STONINGTON COUNTRY CLUB

STONINGTON,
CONNECTICUT

Environmental Review Team Report

Stonington Inland Wetlands Commission

Proposed Site Plan

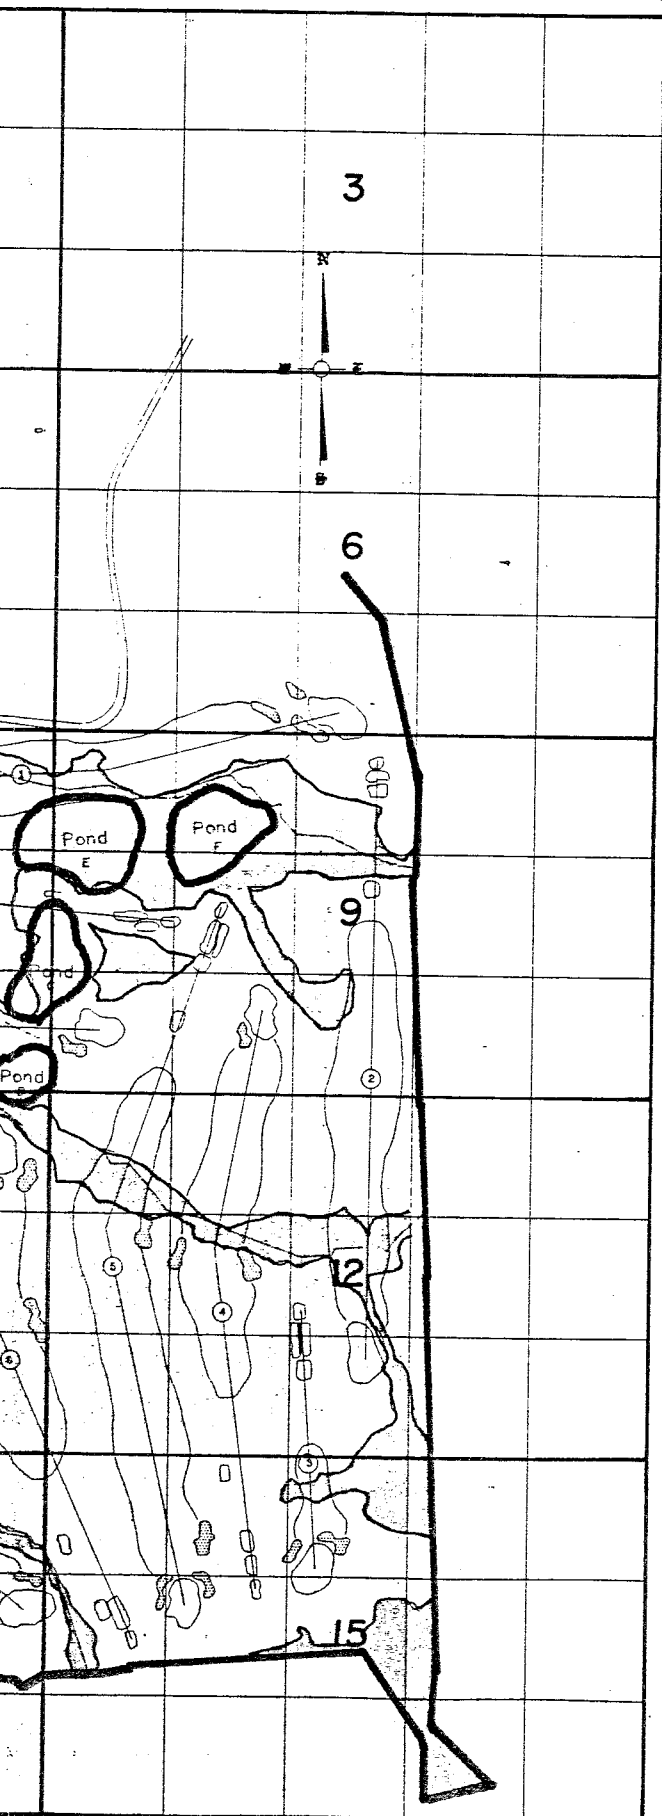
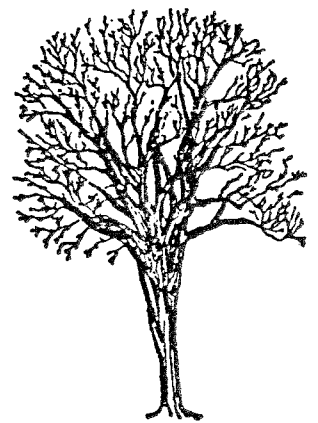
The site plan indicates that 7 new ponds will be used for irrigation (drilled bedrock wells may also be used depending on water demands) and aesthetic purposes. These ponds may also be used for detention, if necessary, and sediment retention, if strategically placed. The ponds and/or irrigation wells should be placed so that runoff is captured from the fairways and re-used on the golf course for irrigation and landscaping purposes. This could reduce transporting pesticide laden water off-site, particularly to Anguilla Brook aquifer.

All ponds will be created by excavating below the water table. Except for the pond located between fairway 10 and 17, all ponds will be constructed partially in regulated wetland soils and will require a permit from the Town's Inland Wetland Commission. The water table in the area of proposed ponds is seasonally high. During spring months when precipitation is at its highest, water levels in the ponds are expected to be good. However, during the summer months when evapotranspiration is high and precipitation levels low, water levels will probably be

Pond Construction: The applicant proposes to construct 7 ponds, 6 of which encroach upon the wetlands. The ponds will serve to collect sediments and nutrients from stormwater runoff as well as irrigate the golf course and provide an aesthetic setting. Ponds B, C, D and G are located partially in the wetlands, while Ponds E and

Fairways: Out of the 18 fairways proposed on this site, Fairways 1, 2, 3, 4, 5, 7, 8, 9, 10, 13 and 14 will result in direct intrusions into the wetlands. The construction of Fairways 7, 10, 13 and 14 involve some filling along the fringes of the wetlands. The construction of Fairways 1, 2, 3, 4, 5, 8, and 9, which transect wetland/watercourse channels, will involve significant alterations of the wetlands and watercourses. For example, the wetland terrain on Fairway 1 is extremely stony and will require heavy machinery to remove the large boulders. Also, curtain drains placed in the wetlands will direct the flow of water into the ponds. This may have the effect of dewatering

The current layout of the fairways and the placement of proposed ponds are not consistent with best design methodology for wetlands protection as envisioned in the State legislation. However, this site can accommodate a golf course and still maintain the natural character and functions of the wetlands and watercourses as they presently exist. The Wetlands Commission should require the submission of alternative configurations of the course that would be more sensitive to the wetland/watercourse resources on the property. Pursuant to CGS Sec. 22a-41(b), a permit should not be issued by the Wetlands Commission if a feasible and prudent alternative exists.

- 1) Scale down the project to a 9-hole golf course. This would reduce the number of ponds required for irrigation and the scope of the impact to the wetlands.

- 2) Evaluate alternate configurations for the fairways. This could involve reducing the length of the fairway (reducing the par on some of the holes), doglegging some of the holes to avoid wetland crossings and eliminating some of the associated facilities (driving range, paddle tennis court, swimming pool, etc.) to place 1 or 2 fairways in those areas.
- 3) Remove the curtain drains from the wetlands. Placing curtain drains in the wetlands to direct the flow of water into the proposed ponds will have a negative impact to the wetlands. If the water supply is not sufficient to keep the ponds adequately filled, perhaps a well could be drilled to insure a sufficient supply of water to the ponds.

- 2) A buffer of 100 feet around wetland areas is recommended. The draft report by Environmental Evaluations states that Fairways 1 and 2 could be altered to avoid the wetland. This adjustment is recommended as well as maintaining a 100-foot buffer between the greens and the wetland areas where possible.
